Medford City Council Public Hearing of 11/1/2018

Public Hearing on the Transportation System Plan – update
File: (CP-16-036)

Siskiyou Velo: Harlan Bittner, President

Figure 1

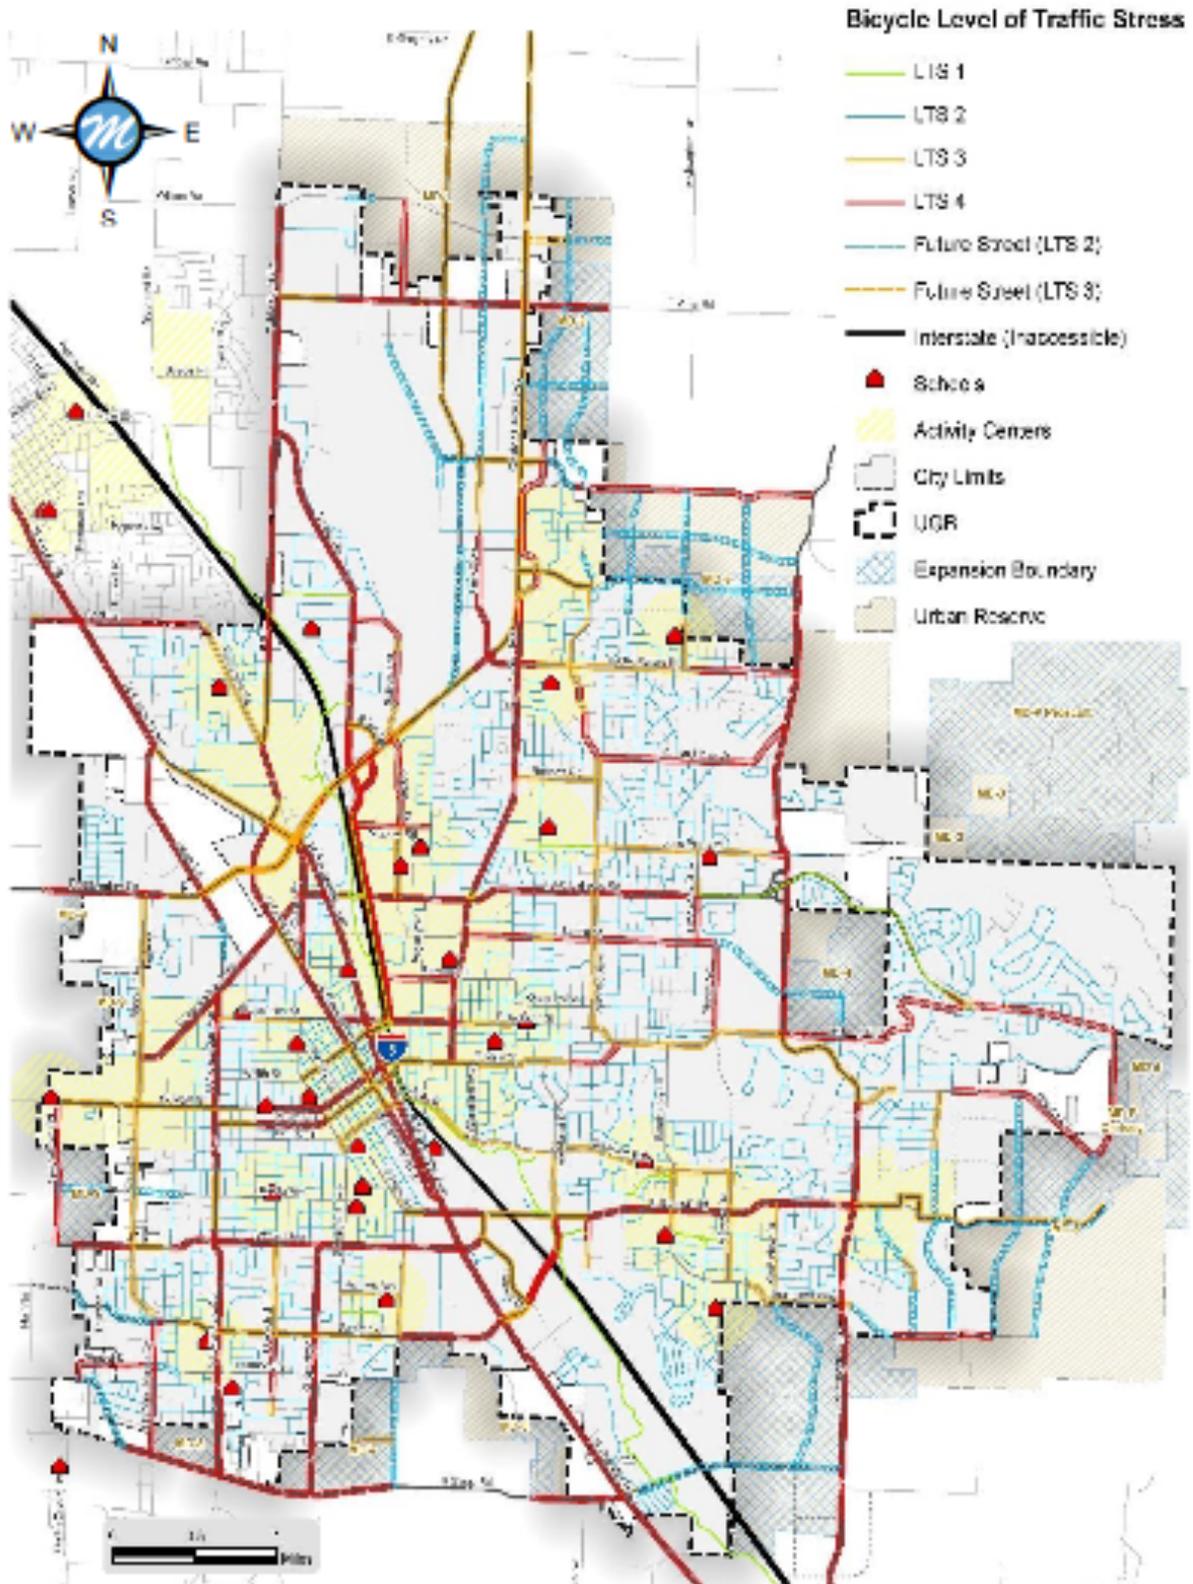
Figure 1 (draft TSP, Figure 10) indicates level of stress (L or LTS) for existing bicycle facilities in Medford. Only Level 1 stress bike facilities, it should be noted, can be used by people of all ages and abilities. There are no existing collector or arterial streets shown on Figure 1 with L1 or L2 stress. There are future streets planned for Level 2 stress—generally, L2 stress facilities can accommodate most adults of ages 18-64 who have “adequate” bicycle handling skills.

All of the City’s collector and arterial streets are either L3 or L4, which are considered unsafe for everyone. The current bicycle network on arterial and collector streets, then, completely excludes children, seniors and families. Analysis of Fig 1 also indicates that riding a bicycle from anywhere to anywhere in Medford is almost impossible on L1 stress facilities—thus excluding vast numbers of all people (including commuters, shoppers, people going to medical appointments, etc.) from riding safely and conveniently in Medford.

The TSP—Update validates these findings, noting on page 34 “that many streets, with bicycle lanes, still result in [high] LTS [Level of Traffic Stress] 3 or 4 ... due to the speed of adjacent traffic.” Thus the City’s existing bicycle transportation system is not “reasonably free from hazards,” a TPR required standard for bicycle facilities (see OAR 660-12-0045(3)(d)(A)).

Figure 2

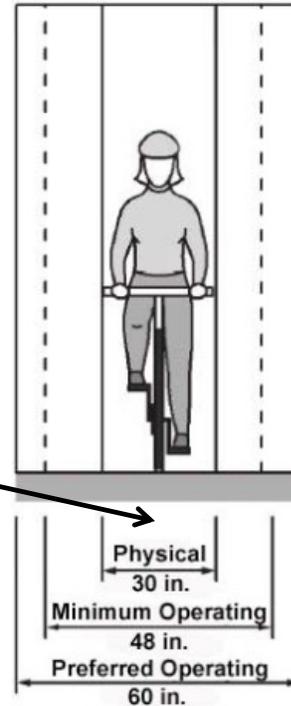
Further compounding the issue is the City’s historic construction of overly narrow bike lanes on most of its arterial and collector streets. The problem is illustrated in Figure 2 with additional examples included in Appendix 1. Many of the bike lanes on major (arterial and collector) streets do not meet the City’s street standards, which require 5’ wide bike lanes except on major arterials, where 6’ wide bike lanes are required. The resulting close proximity of bicycles and traffic results in higher Levels of Stress on many streets than indicated in Figure 1. The TSP--Update does not include any description of the LTS methodology but it likely relied upon the flawed inventory indicated here.

Medford, like the rest of the RVMPO cities, have focused almost exclusively on adding bike lanes on major streets (arterial and collector streets). **The City's efforts have often lead to overly narrow lanes for bikes** despite the City's street standards which require five feet wide bike lanes except on major arterials where the City's code* requires bike lanes to be six feet wide (both measures include the width of the drain pan).

Two and one-half feet wide. That is too narrow for safety or comfort.

Figure 1

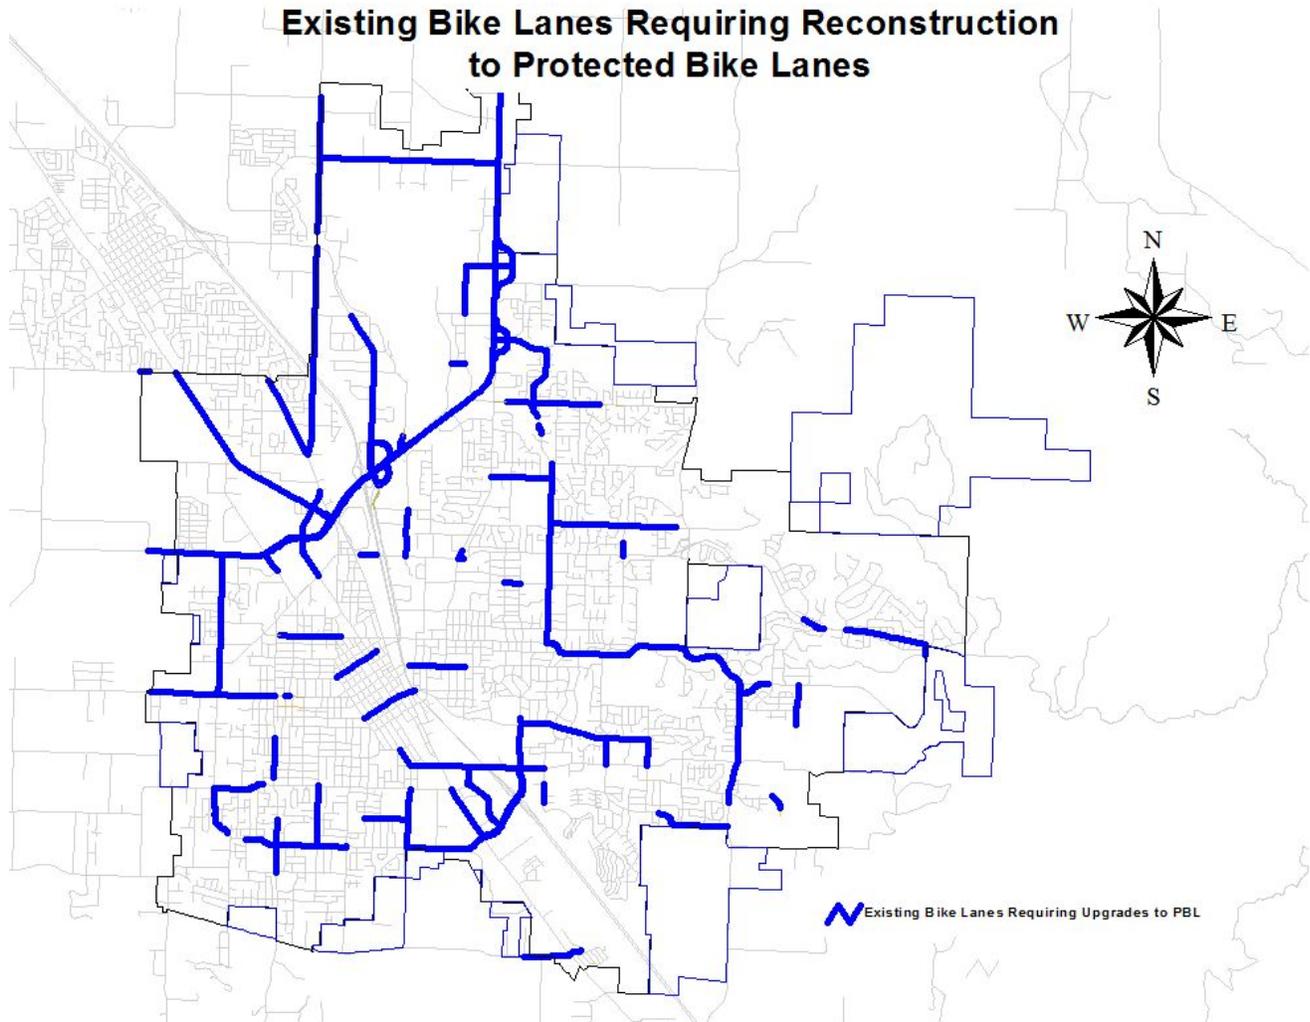
The City does not reflect in its funding priorities the extraordinary back-log of unsafe, substandard bicycle bike lanes (see Appendix A) which need to be upgraded to protected bike lanes (see Figure 1) in order to ensure the safety of people riding bicycles. Figure 13 illustrates the extent of the problem but nowhere are those needs itemized. Using the City’s GIS data sets, the total computed mileage of needed protected bike lanes exceeds 100 miles.* These needs will go almost entirely unmet and are not itemized in the draft TSP.

NOTE: The City's classification of "bike lane" includes those less than four feet wide, and those without proper striping and the required bike rider symbols. The latter are on OR99, OR238, and at the South Medford Interchange; all ODOT facilities.

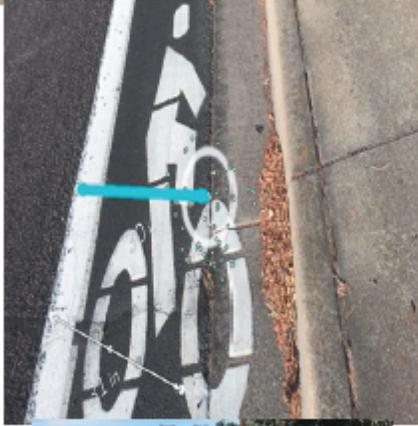
Bike lane to the right of right-turn only lane,
Barnett and N Phoenix.

Too narrow bike lane (3 feet, as indicated by blue
line), Springbrook.

Disappearing bike lane on Springbrook.
